May 5, 2004
FCC ID: NKRCRP-1

Here are our answers:

The photos below are the peak power analyzer & self-calibration

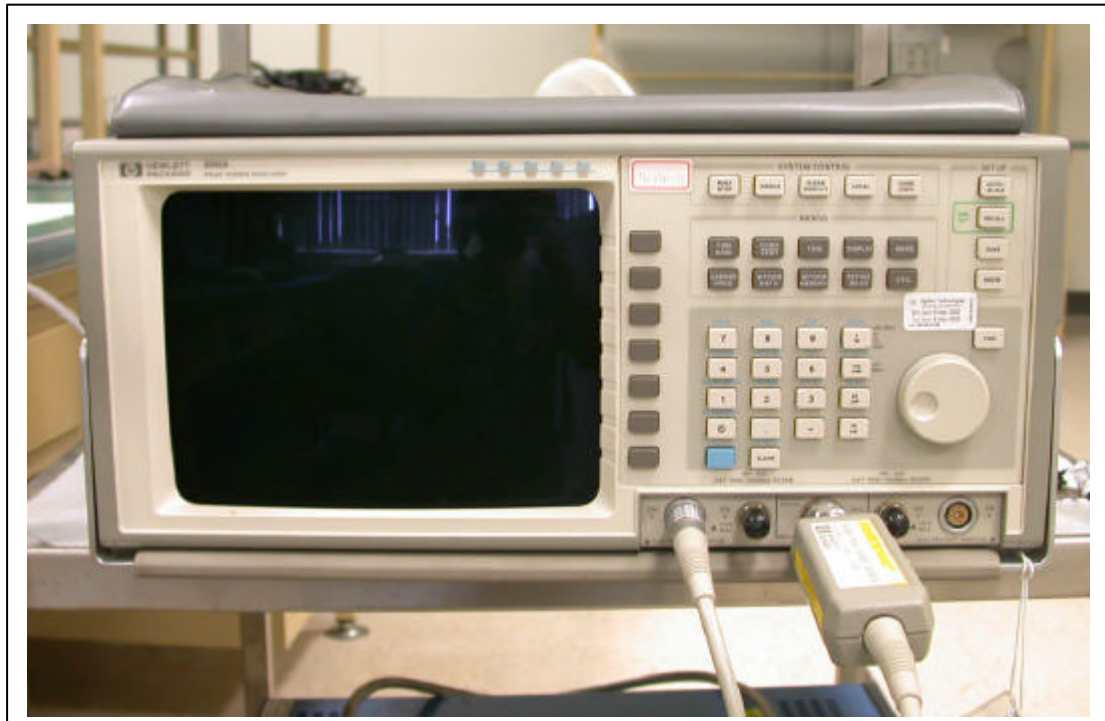
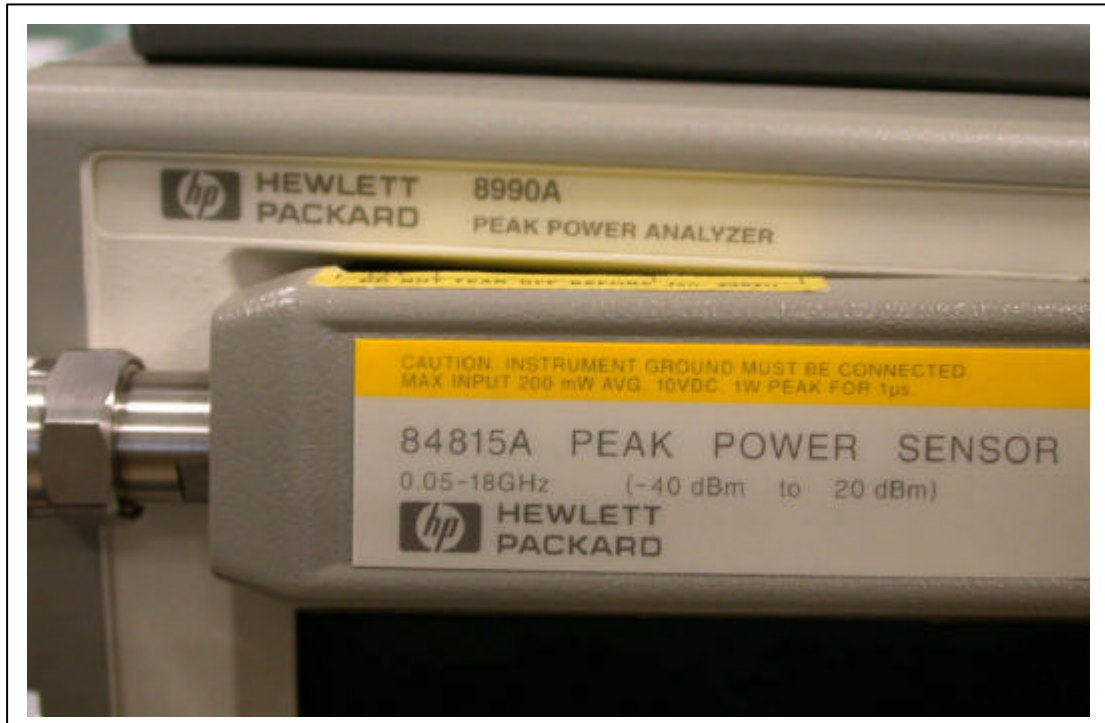
1)See updated Bolck Diagram
2) See MPE update report
3) See updated P2 of test report
4) The peak power analyzer is containing a power sensor (HP 84815A) and a power analyzer (HP8990A). The peak power analyzer is not a spectrum analyzer, and it doesn't need the resolution bandwidth filter inside. The peak power analyzer is same with the peak power meter, and it has video bandwidth filter inside. The list below is the spec.
.

For our measurement, the VBW is 150MHz larger than the bandwidth, no need to add the correction factor.

The attentuator is inside the power sensor (HP 84815A), and it prevents the over-current damaging the power analyzer. Before we test, we connect the power sensor's output- port to the sensor-check-port of the power analyzer, then the analyzer

will self-calibrate the attenuator's loss by himself automatically, we didn't need to do any thing at the attenuator and didn't know the loss any more.
